Work Order ID 154605

Item Name: Baggage Compartment Protector - Floor

DART SERVICE INSTRUCTION

TO AMEND INSTALLATION INSTRUCTIONS IIN-D407-781-2 REV. A OR LATER APPROVED REVISION
AND INSTRUCTIONS FOR CONTINUED AIRWORTHINESS ICA-D407-781 REV. 3 OR LATER REVISION

**FIGURE 1 - D3879-1 BAGGAGE COMPARTMENT WALL
PROTECTOR - ALTERNATE INSTALLATION**

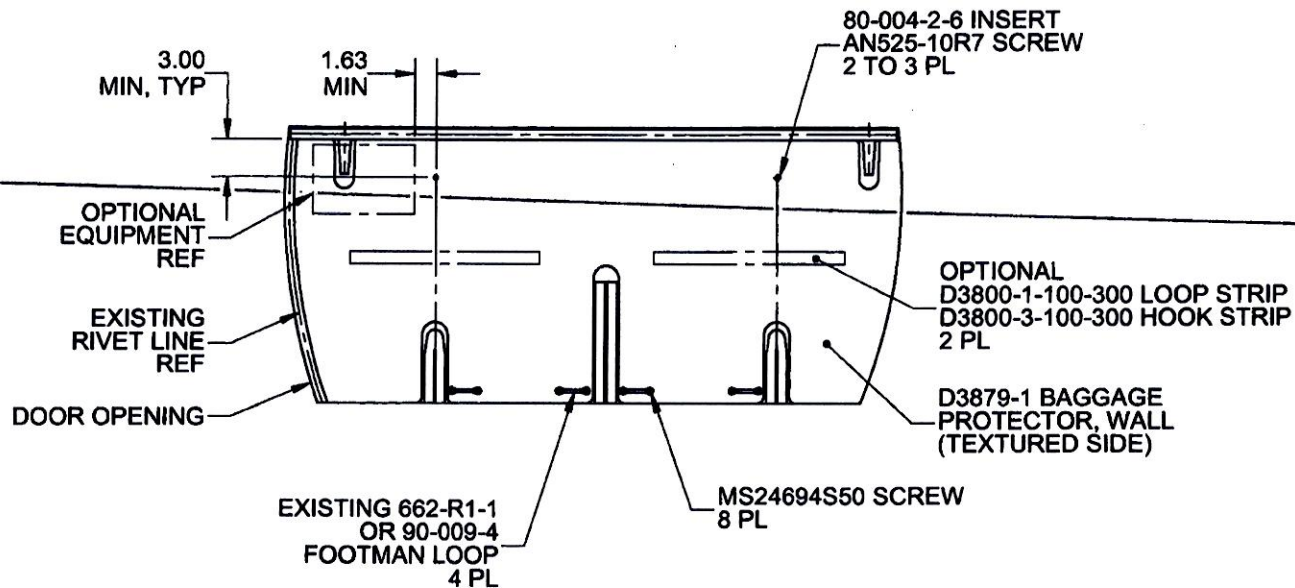
In some aircraft, the top portion of the D206-781-041 Baggage Compartment Wall Protector Kit cannot be installed as indicated in IIN-D407-781-2. The purpose of this DSI is to provide an alternate mounting method to fasten the top portion of the D206-781-041 Baggage Compartment Wall Protector Kit.

It is acceptable to replace qty(2) D3930-1 Clips with qty(2) 80-004-2-6 Inserts. Locate and mark location of the two attachment holes on the baggage compartment wall as shown in Figure 1 of this service instruction. Install 80-004-2-6 Inserts at the marked locations in accordance with Section 3-2-12 of BHT-206-SRM-1. It is acceptable to trim the wall protectors to accommodate optional equipment or transfer attachment holes to the wall protector and install the optional equipment on top of the wall protector with longer fasteners.
